Administrative Committee of the European Agreement
Concerning the International Carriage of Dangerous
Goods by Inland Waterways (ADN)

European Agreement concerning the International Carriage of Dangerous Goods by Inland Waterways (ADN) ¹

Draft amendments to the Regulations annexed to ADN

Figure 5.2.1.9.2

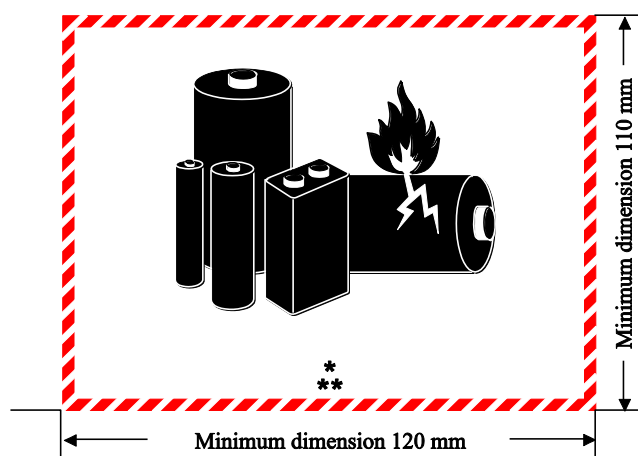
5.2.1 Add a new 5.2.1.9 to read as follows:

5.2.1.9.1 Packages containing lithium cells or batteries prepared in accordance with special provision 188 shall be marked as shown in Figure 5.2.1.9.2.

5.2.1.9.2 The mark shall indicate the UN number preceded by the letters “UN”, i.e. ‘UN 3090’ for lithium metal cells or batteries or ‘UN 3480’ for lithium ion cells or batteries. Where the lithium cells or batteries are contained in, or packed with, equipment, the UN number preceded by the letters “UN”, i.e. ‘UN 3091’ or ‘UN 3481’ as appropriate shall be indicated. Where a package contains lithium cells or batteries assigned to different UN numbers, all applicable UN numbers shall be indicated on one or more marks.

Examples of stowage and segregation of containers

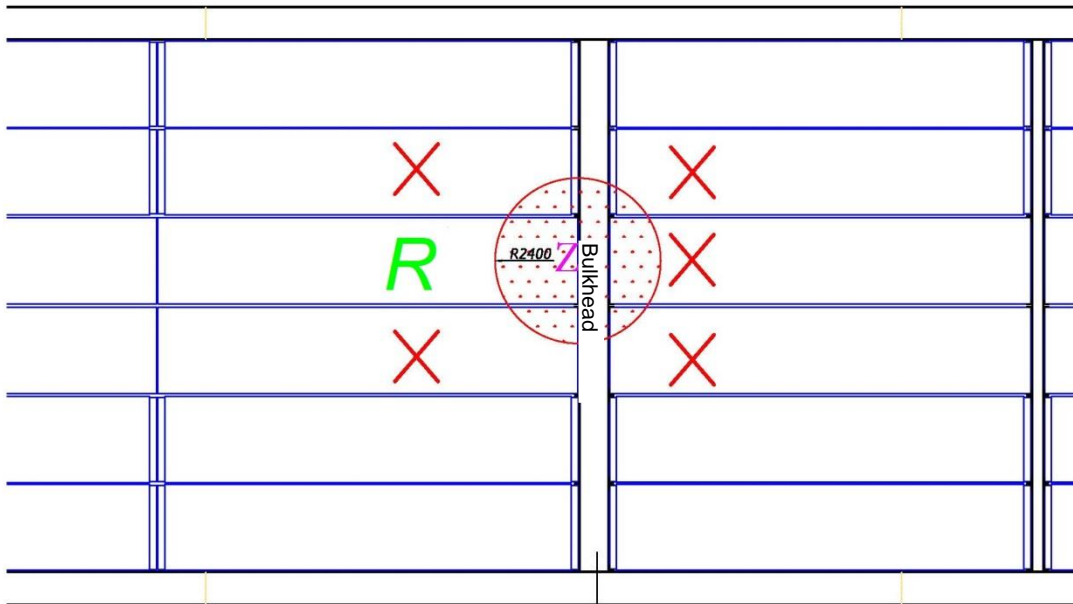
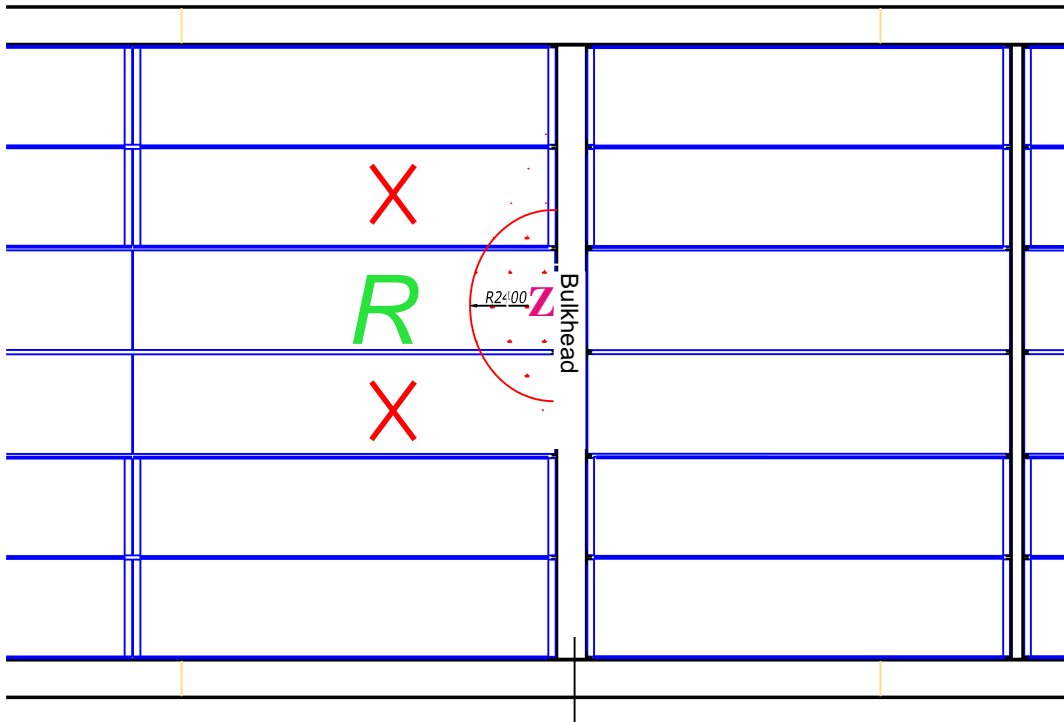
This condition is deemed to be met if no container containing the above-mentioned substances is stowed within an area of cylindrical form with a radius of 2.4 m around the electrical equipment and an unlimited vertical extension.

This condition does not apply if containers with electrical equipment which is not of a certified safe type and containers containing the above-mentioned substances are stowed in separate holds.
